SUBJECT: ISSUANCE OF AMENDMENT NO. 43 TO FACILITY OPERATING LICENSE  
NO. NPF-21 - WPPSS NUCLEAR PROJECT NO. 2 (TAC 64358)

WPPSS Nuclear Project No. 2  
(WNP-2)

Amendment No. 43  
License No. NPF-21

ENCLOSURE TO LICENSE AMENDMENT NO. 43

SODIUM PENTABORATE TANK, VOLUME VS. CONCENTRATION REQUIREMENTS

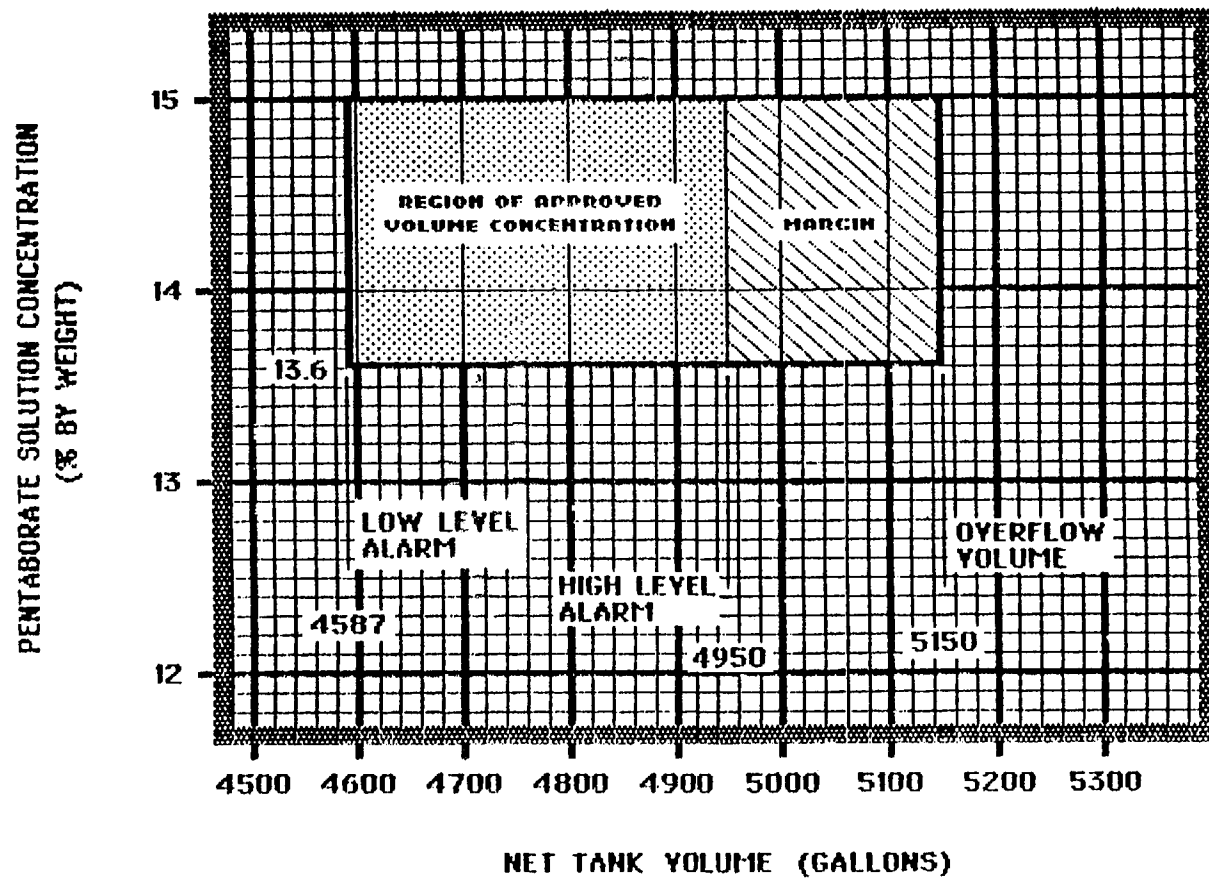
This amendment revises Section 3/4.1.5, Standby Liquid Control (SLC) System Surveillance Requirements, of the WNP-2 Technical Specifications to permit compliance with the ATWS regulation, 10 CFR 50.62(c)(4) to be achieved with two existing 41.2 gpm SLC pumps by effecting an increase in the sodium pentaborate decahydrate solution concentration in conjunction with simultaneous operation of the two pumps. Related Figures 3.1.5-1 and 3.1.5-2 are also modified.

By letter dated January 6, 1987 as clarified by letters dated March 3 and March 12, 1987, the Washington Public Power Supply System proposed certain changes to Section 3/4.1.5, Standby Liquid Control (SLC) system, and referenced Figures 3.1.5-1 and 3.1.5-2 of the Technical Specifications for WNP-2.

The Standby Liquid Control system provides a backup capability for bringing the reactor from full power to a cold, Xenon-free shutdown assuming that none of the withdrawn control rods can be inserted. Applicable ATWS regulations require, as set forth in 10 CFR 50.62(c)(4), that the SLC system be capable of injecting at a minimum flow capacity and boron content equivalent in control capacity to 86 gpm of 13 weight percent sodium pentaborate solution. The licensee has proposed that this equivalency be achieved by simultaneous operation of two SLC pumps, each with a capacity of 41.2 gpm, and with sodium pentaborate decahydrate concentration increased to 13.6 weight percent.

For Anticipated Transient Without Scram (ATWS), mitigation requires an equivalent 86 gpm -- 13% sodium pentaborate decahydrate pumping rate. This requirement is met by running both standby liquid control (SLC) pumps simultaneously. At the minimum allowable single pump pumping rate (41.2 gpm), and with two pumps operating, a 13.6% sodium pentaborate decahydrate concentration will provide the required equivalent injection rate. Maintenance of the SLC solution volume and concentration within the limits established ensure that the single pump shutdown and ATWS requirements can be met.
